**SERVICE BULLETIN – Standard Rolling Roof Rig Base Assembly**

In an effort to assure the safety of, and to continuously improve the quality of our products, we at Sky Climber conduct internal quality audits and request feedback from our customers on their experiences using our products. Based on information generated from these activities, we have introduced a product concern with the Standard Rolling Roof Rig (RRR) 154-24-02 Base Weldment.

**REFERENCE:** Use drawing 154-24-02 Rev.D to locate and identify locations for inspection. Joints for inspection are circled in **Red**.

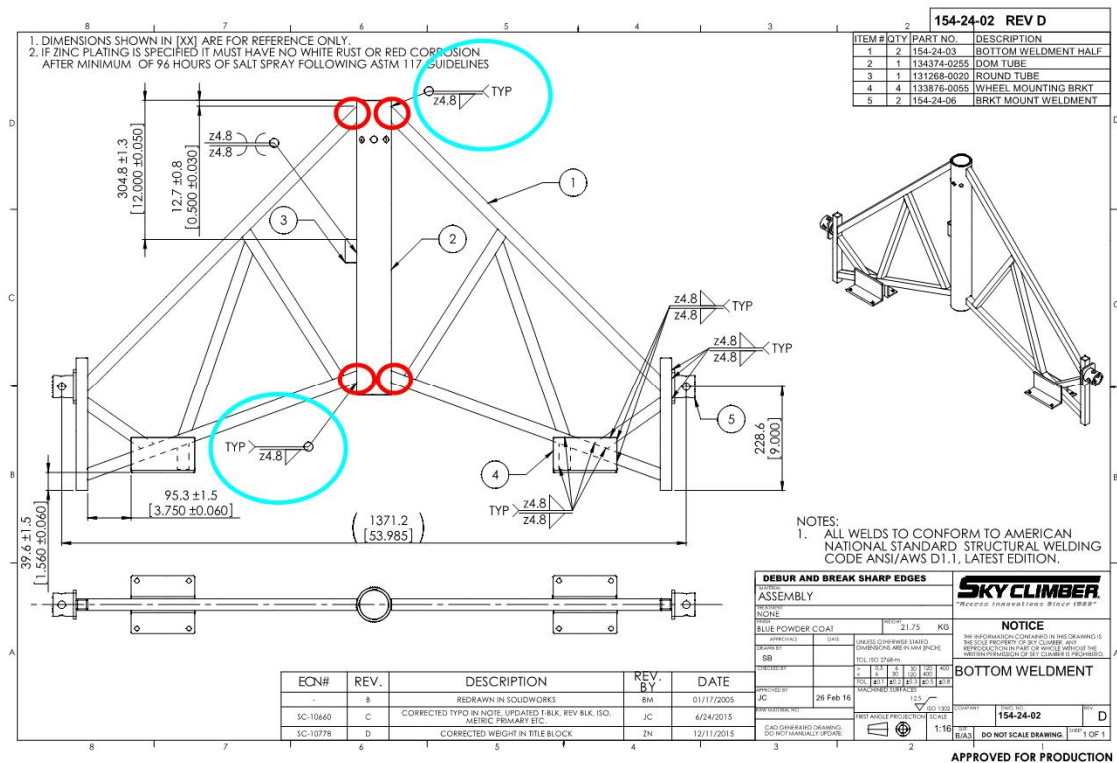
CURRENT INFORMATION: The supplied pictures indicate that a junction weld between one of the Bottom Weldment half and the DOM tube was only welded on 3 sides of the junction. All four connection joints of the 2 base halves and the center DOM tube should be welded on all 4 sides. NOTE: Other pieces within the base weldment half may be welded on only 3 sides per the 154-24-03 print.

**COMPLIANCE:** **MANDATORY** – The 4 weld connections indicated in the drawing below, must be welded continuously around on all 4 sides. If not, the unit should be removed from service and returned to Sky Climber for rework or replacement.

1. Locate and visually inspect the 4 junction welds as indicated in the drawing above.
2. If any of the 4 junctions appear to not be welded completely around all 4 sides, red tag the weldment and remove from service as soon as possible.
3. For units in the field, replace all suspect weldments with a known good replacement.
4. Photograph the suspect weldment and call Sky Climber Customer Service to order a replacement weldment.
5. Sky Climber may issue a Return Authorization number to return unit for rework or have you scrap and replace depending on the apparent age and condition of the weldment. Sky Climber will seek replacements from our supplier who in turn will ask for payment of the scrap value of destroyed units.
6. Replacement units may be new or reworked units at Sky Climber's discretion.
